# Access Compliance Report

## Public Rights-of-Way

### (Curb Ramps)

Intersection ID: N/A	Main Street: INDEPENDENCE_BV	Cross Street: N/A	Location: SW
ADA ID: 14E79C4B9AED	Ramp Type: Perp	Initial Pass/Fail: Fail	Overall Compliance: No
Severity Score: 13.75			
Codes/Mitigation Info/Possible Solution		Field Measurements/Component Compliance

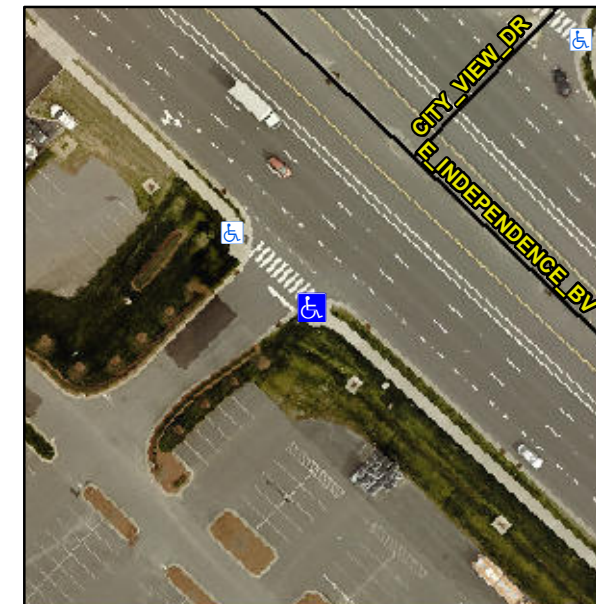
**Not Found, R304.2.2, R304.5.3**

Compliance	Description	Data	Compliance	Description	Data
N/A	Ramp Length (in)	71.5	No	Ramp Slope (%)	9.6
Yes	Ramp Width (in)	59.5	No	Ramp XSlope (%)	4.3
N/A	Flare Type LT	N/A	N/A	Flare Type RT	N/A
N/A	Flare Slope LT (%)	N/A	N/A	Flare Slope RT (%)	N/A
N/A	Flare Traversable LT?	N/A	N/A	Flare Traversable RT?	N/A
N/A	Landing Length (in)	N/A	N/A	DWS Provided?	N/A
N/A	Landing Width (in)	N/A	N/A	DWS Contrast?	N/A
N/A	Landing Slope (%)	N/A	N/A	DWS Length (in)	N/A
N/A	Landing X Slope (%)	N/A	N/A	DWS Full Width?	N/A
N/A	Landing Curb? (Y/N)	N/A	N/A	DWS Offset (in)	N/A
N/A	Shared Landing?	N/A			
N/A	Gutter Ponding?	N/A	N/A	Gutter Slope (%)	N/A
N/A	Gutter Lip Ht (in)	N/A	N/A	Gutter X Slope (%)	N/A
N/A	Painted X Walk1?	Yes	N/A	Painted X Walk2?	N/A
	X Walk 1 Direction	To NW		X Walk 2 Direction	N/A
N/A	X Walk 1 Width (in)	120.5	N/A	X Walk 2 Width (in)	N/A
	X Walk 1 Slope (%)	0.1		X Walk 2 Slope (%)	N/A
	X Walk 1 X Slope (%)	7.2		X Walk 2 X Slope (%)	N/A

**Remove & Replace Entire Ramp.**
